REQUEST FOR COMMITTEE ACTION

HENDERSON COUNTY TECHNICAL REVIEW COMMITTEE

SUBJECT: Combined Master and Development Plan for the Meadows at Rivers Edge (File

Combined Master and Development Plan Review for the Meadows at Rivers Edge (File #2010-M01)

Map A: CCP Future Land Use

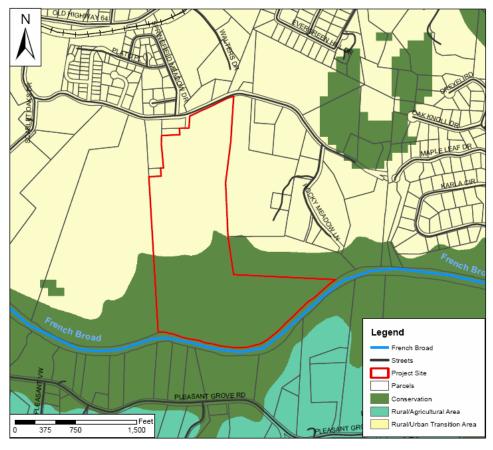
- 1. *Henderson County 2020 Comprehensive Plan* (CCP). The Future Land Use Map of the CCP shows the project site as being located within the: Rural Transition Area (See Map A: CCP Future Land Use Map). In the Rural Transition Area population and residential densities should be generally lower than the more urban densities found within the Urban Services Area and should be generally in keeping with topography, septic limitations, and school and transportation capacities.

- **a.** The Rural/Urban Transition Area is currently rural in character, with existing pockets of limited higher density residential and commercial development. The proposed project density complies with the R2R zoning districts allowable density and the actual density is 1 unit per 1.41 acres.

- **b.** The Conservation Area includes land areas that are intended to remain largely in their natural state, with only limited development. These are likely to be sensitive natural areas, such as steep slopes, streams, creeks, waterfalls, forest reserves, wildlife conservation areas and key watersheds. The conservation area shown in Map A reflects the former 1982 floodplain maps. These maps were amended in 2008, reducing the

floodplain within the project site. According to the Master and Development Plan a majority of the floodplain areas are proposed to be conserved as open space. (See Map A: CCP Future Land Use Map and Map C Floodplain Map)

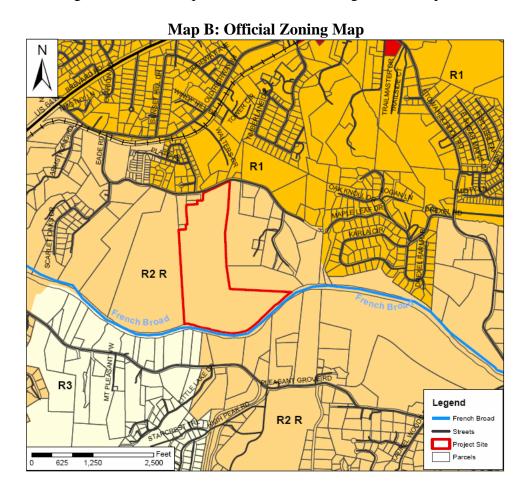
According to Chapter 200A, Henderson County Land Development Code (LDC) and its Official Zoning Map adopted September 19, 2007 (as amended), the proposed project site is located within the R2R (Residential Two Rural) zoning district. (See Map B: Official Zoning Map). The maximum single family density for the property is 76 dwelling units. The applicant is proposing 54 single family dwelling units which complies with the R2R zoning districts requirements.

Map C: Floodplain Map

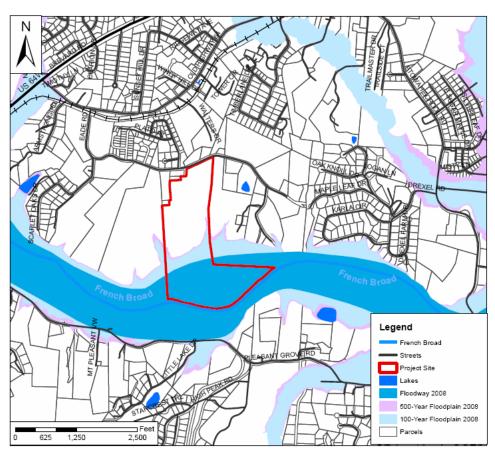
3. **Flood Damage Prevention Regulations.** According to County records the majority of the southern portion of the project site is within the 100 year floodplain or floodway. The majority of the project site within the floodplain is proposed as conservation area. Constructing buildings within the floodplain should be avoided. (See Map C: Floodplain Map).

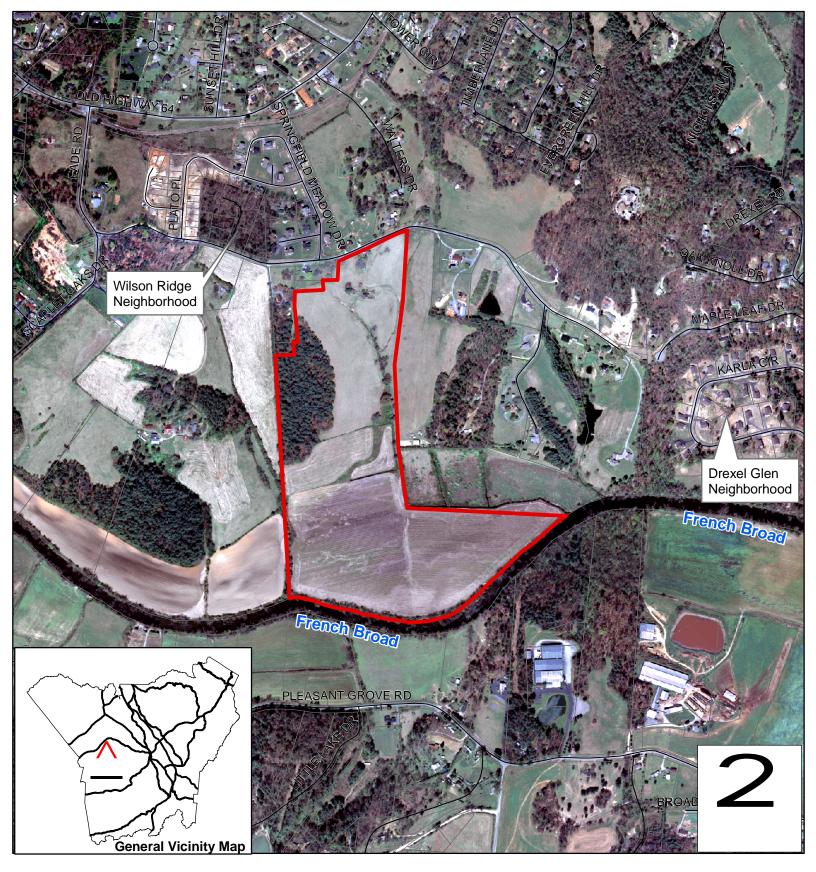
- 5. **Street Tree Requirements.** According to the street tree requirements of Chapter 200A (LDC §§200A-145 and 200A-146) the applicant must provide one tree per 50 linear feet of property abutting an internal road. Trees may be placed in groups with a minimum spacing of no less than 15 feet and a maximum spacing of no more than 65 feet. The trees must be placed within the right-of-way or within 20 feet of the edge of the right-of-way. The applicant may use existing trees in accordance with §200A-153 instead of planting new trees. These existing trees must also be located within the right-of-way or 20 feet of the edge of the right-of-way as required by §200A-146.

It appears that the applicant is proposing 153 new trees to satisfy the street tree requirements. All of the street trees shown are within the right-of-way. It appears the spacing requirements for the street trees will be met. The TRC may alter street tree requirements because of adverse site conditions (LDC §200A-155).

Waters Edge Road would be required to be extended to the edge of the property line (see above comment #4). This addition, would add approximately 170 additional feet of road frontage to the project and would thus require the addition of 3 more street trees for a total of 80 street trees required for Waters Edge Road. All street trees must be properly planted and meet the spacing requirements or the applicant may post an improvement guarantee with the County before the final plat for the subdivision can be approved.
